ADDENDUM NO. 3

DATED: November 14, 2024

PROJECT:	WSD New Sr. High School	**DATE:**	11/14/2024
OWNER:	Wynne School District	**PROJECT NO:**	A-23010
TO:	Gary Hoyt Nabholz Construction	**CONTRACT FOR**:	General Construction

SHEET NUMBER
C3.12

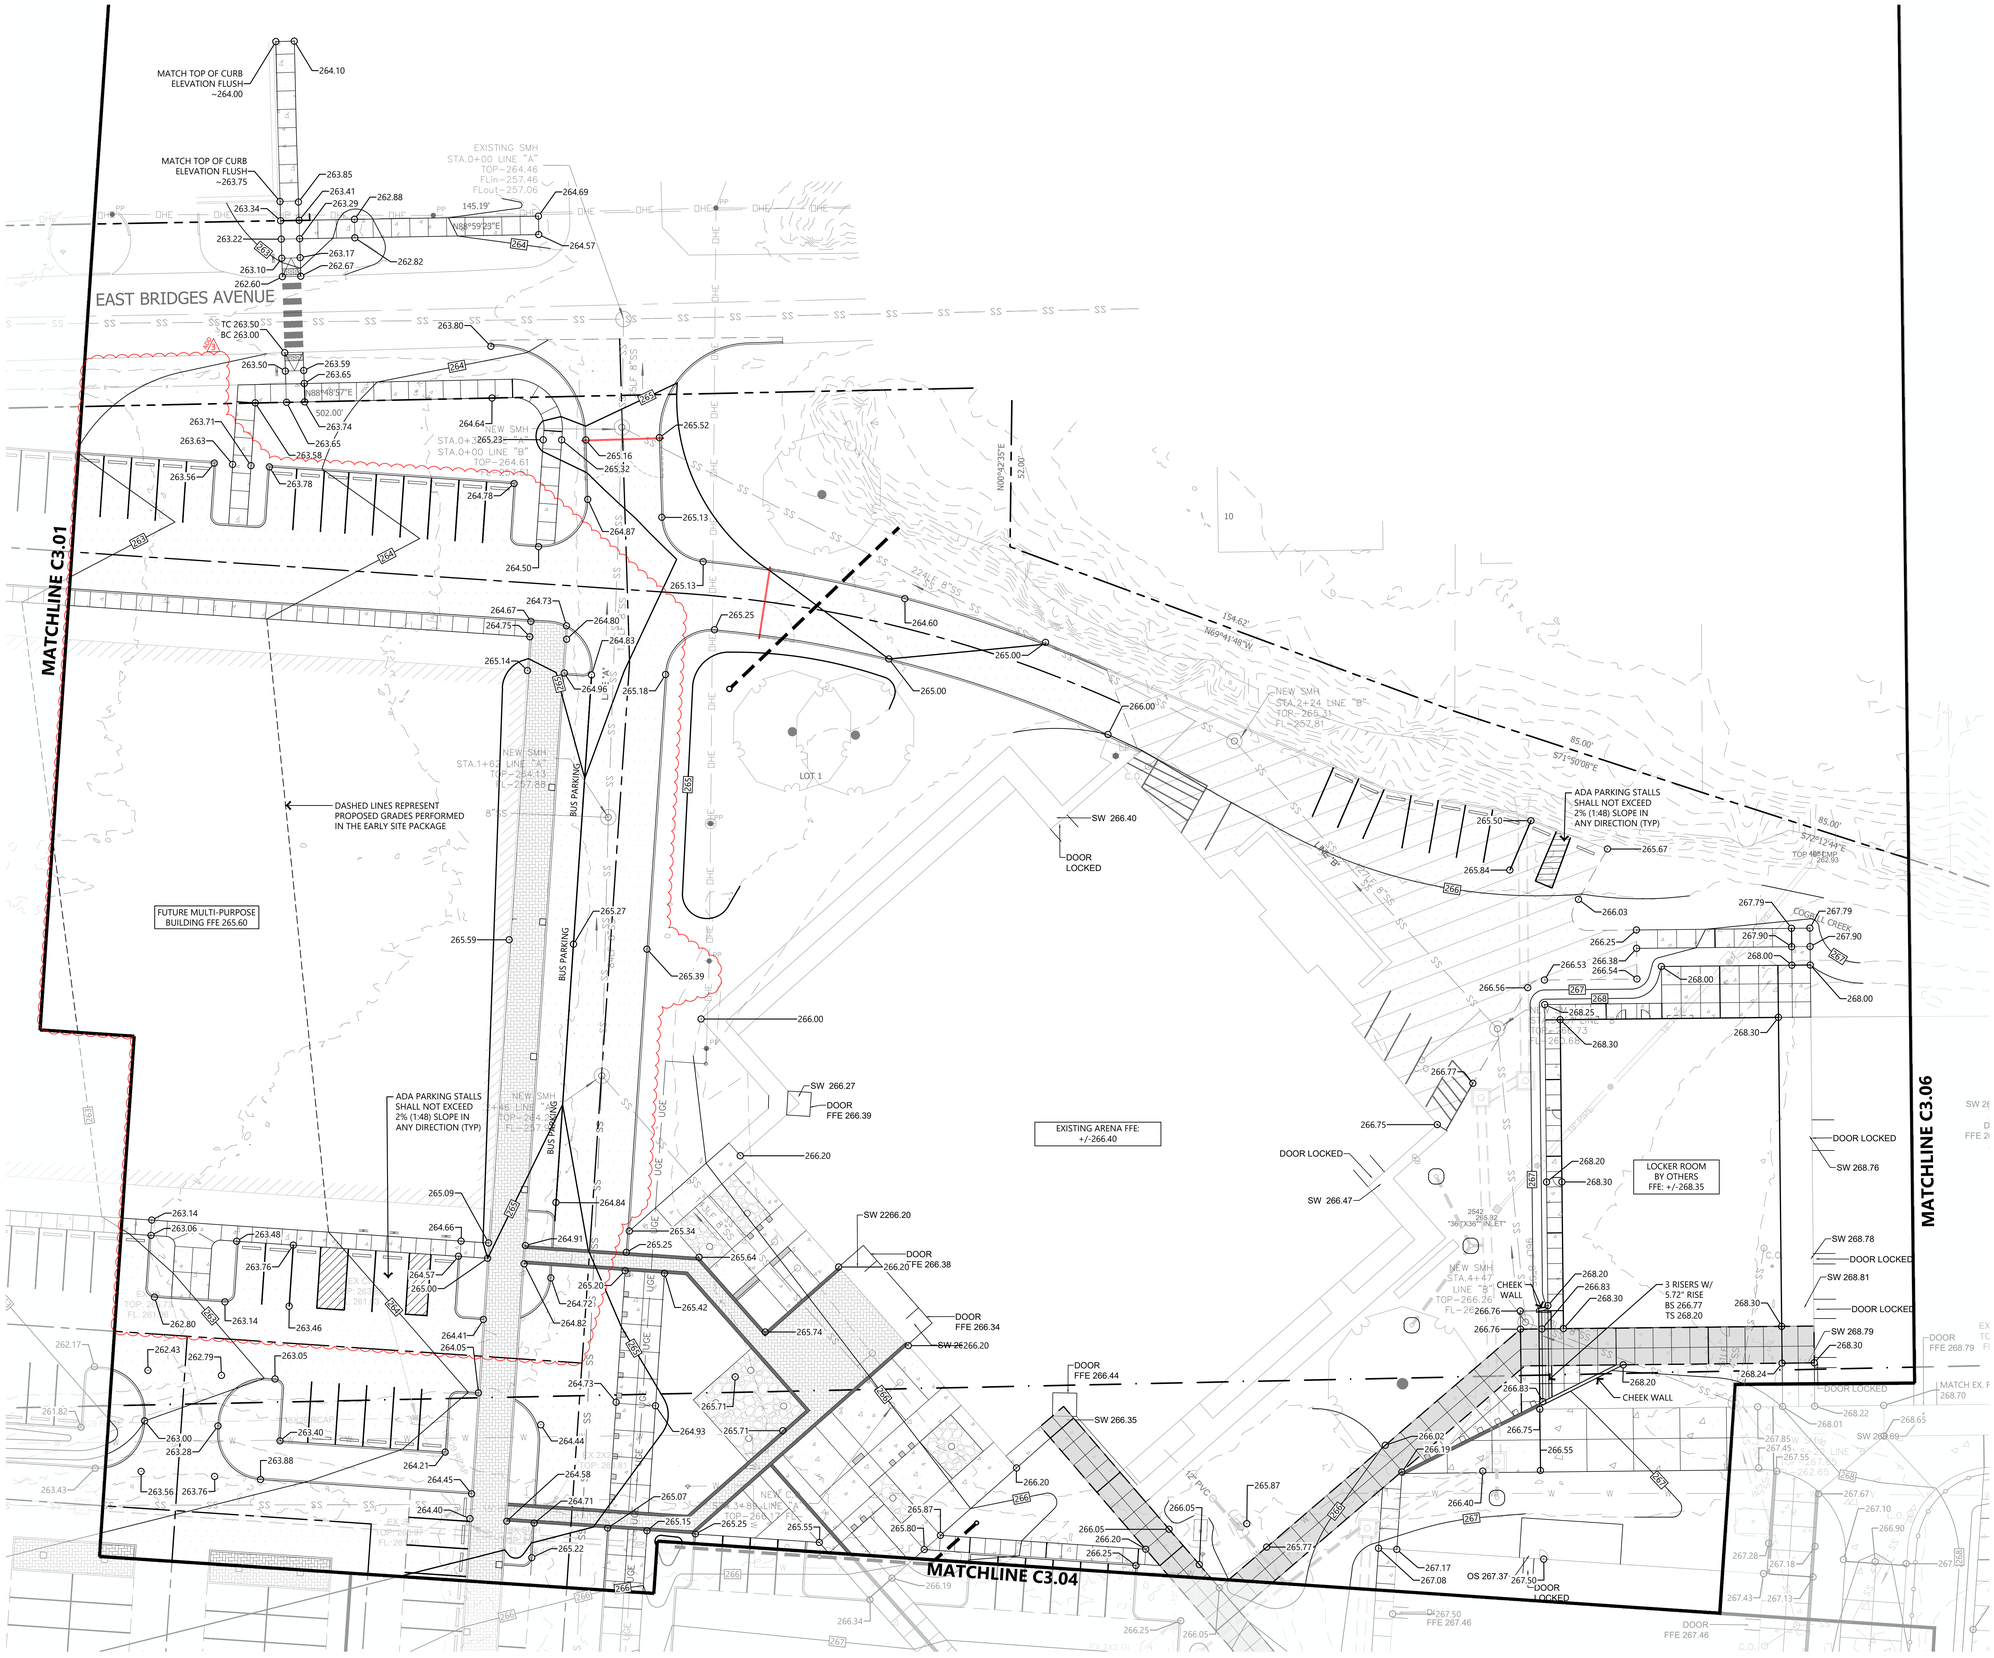
16. Sheet C3.12 SPOT ELEVATION PLAN: Drawing has been updated and revised as indicated on drawing sheet.

SHEET NUMBER
C4.00

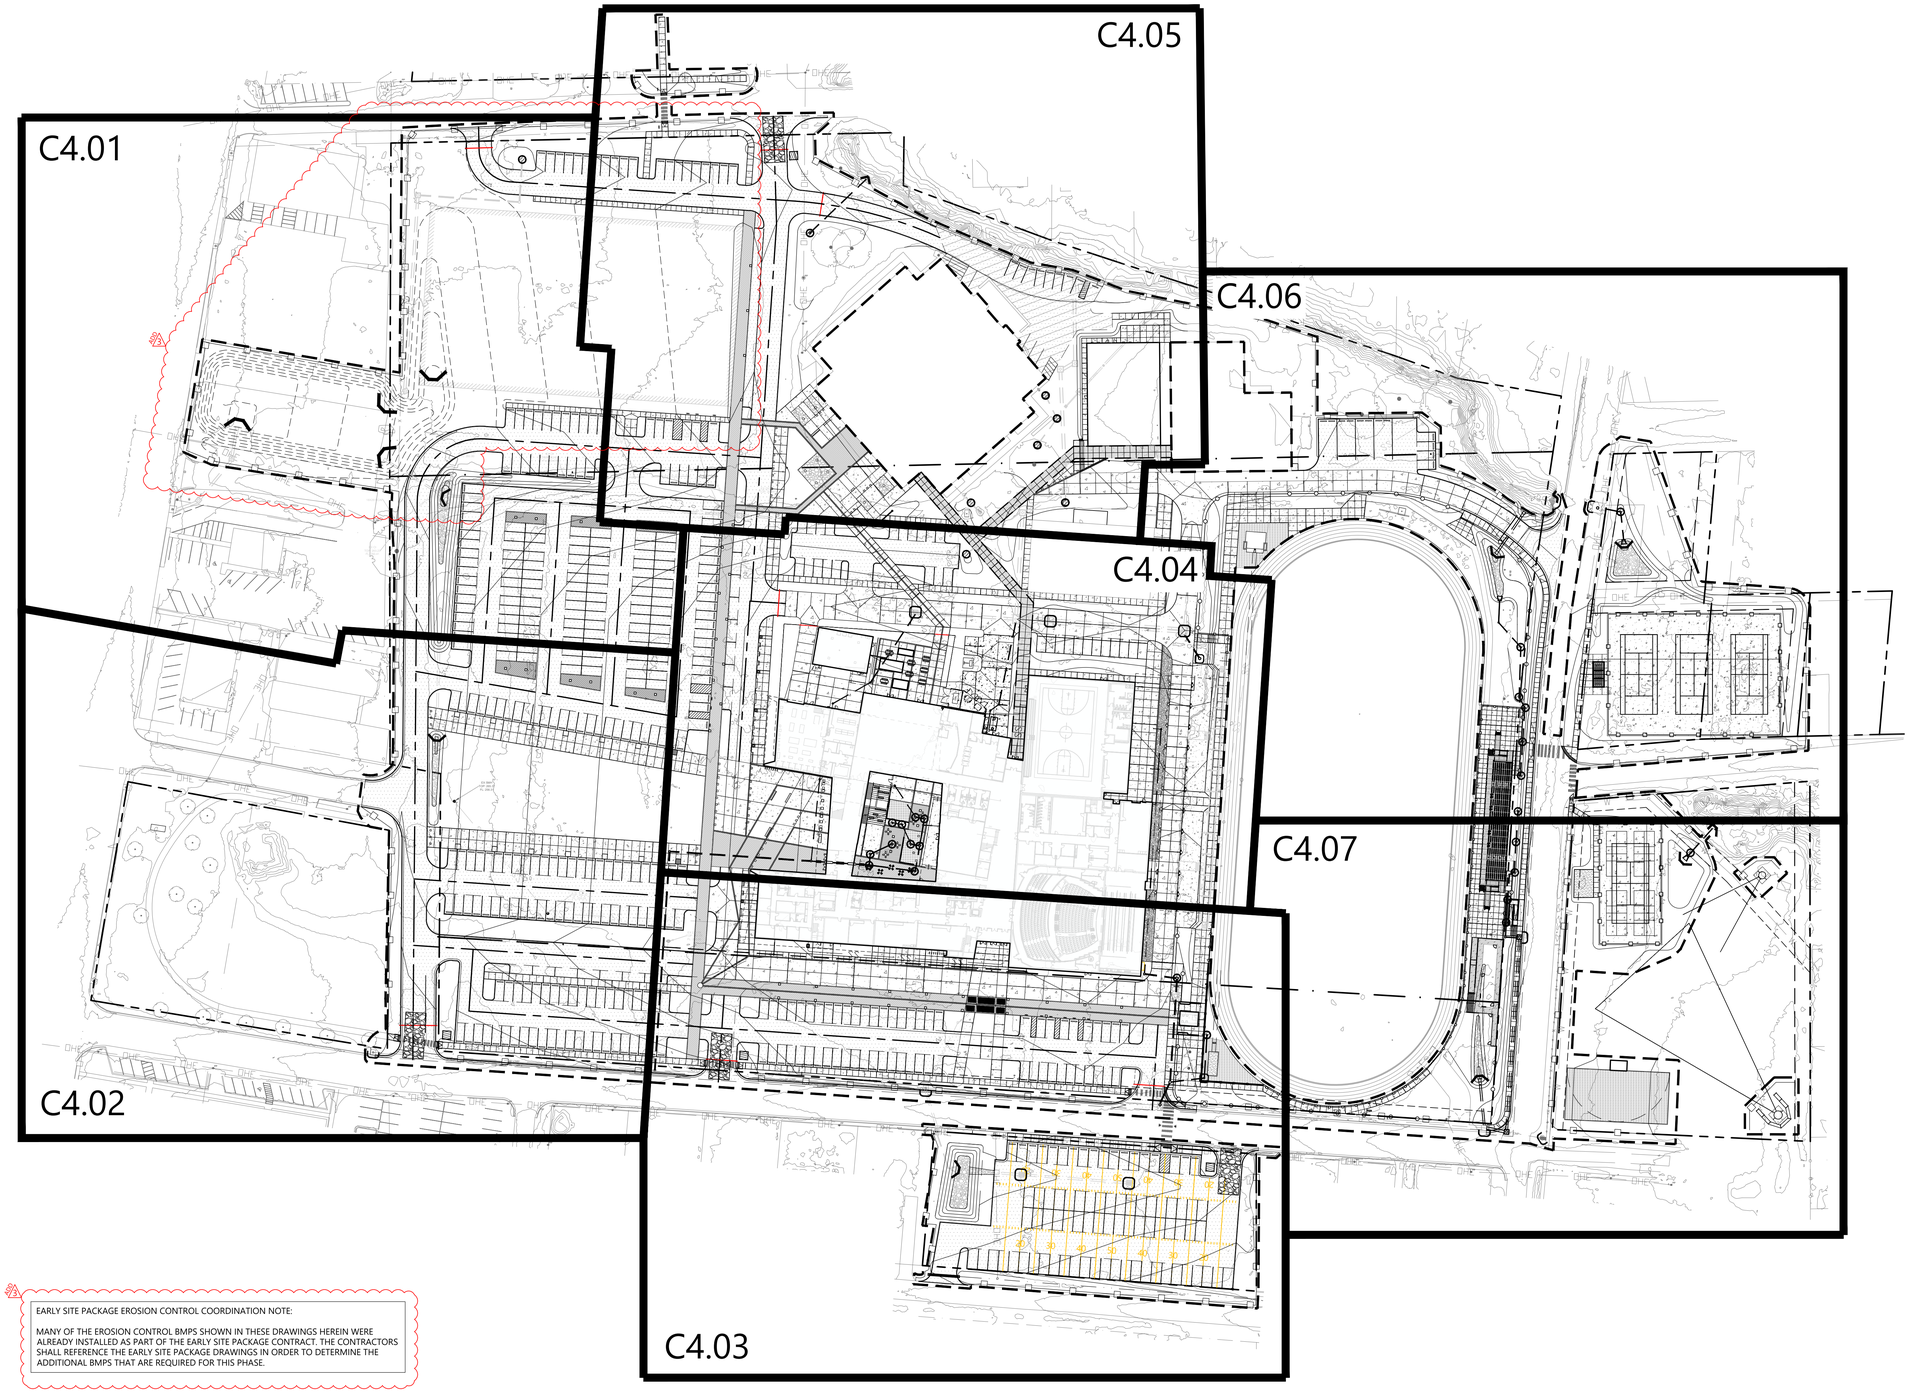
17. Sheet C4.00 OVERALL EROSION CONTROL PLAN: Drawing has been updated and revised as indicated on drawing sheet.
18. Sheet C4.01 EROSION CONTROL PLAN: Drawing has been updated and revised as indicated on drawing sheet.

SHEET NUMBER
C4.05

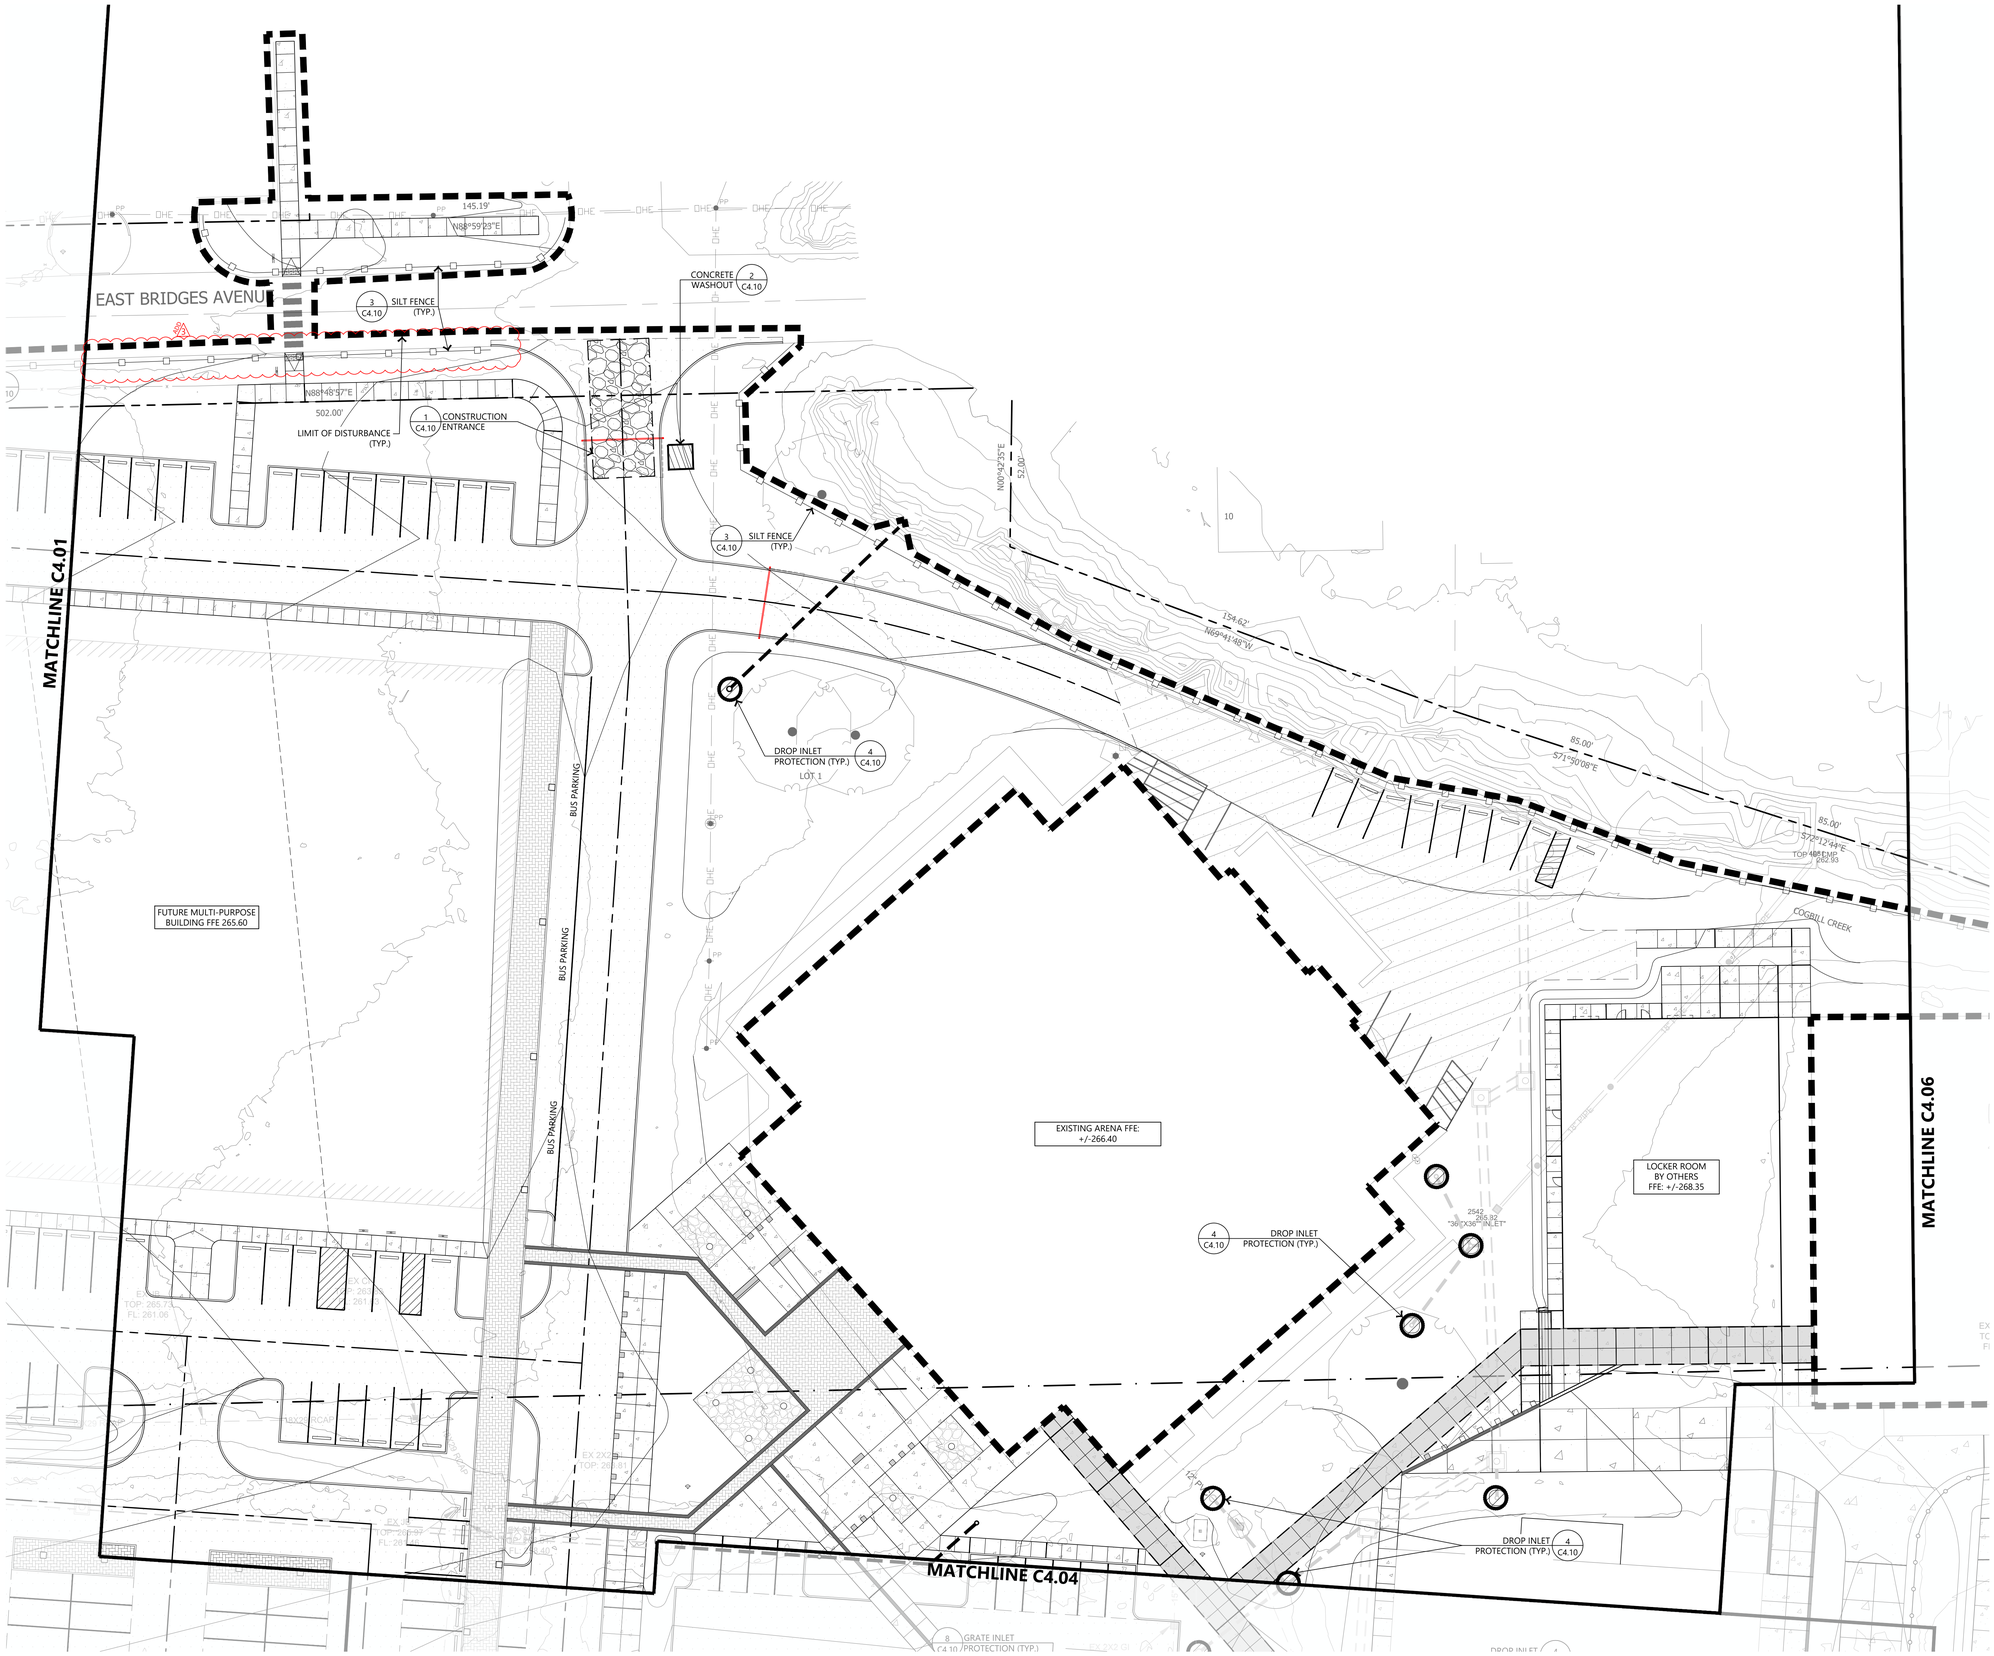
19. Sheet C4.05 EROSION CONTROL PLAN: Drawing has been updated and revised as indicated on drawing sheet.
20. Sheet C5.01 SITE DETAILS: Drawing has been updated and revised as indicated on drawing sheet.
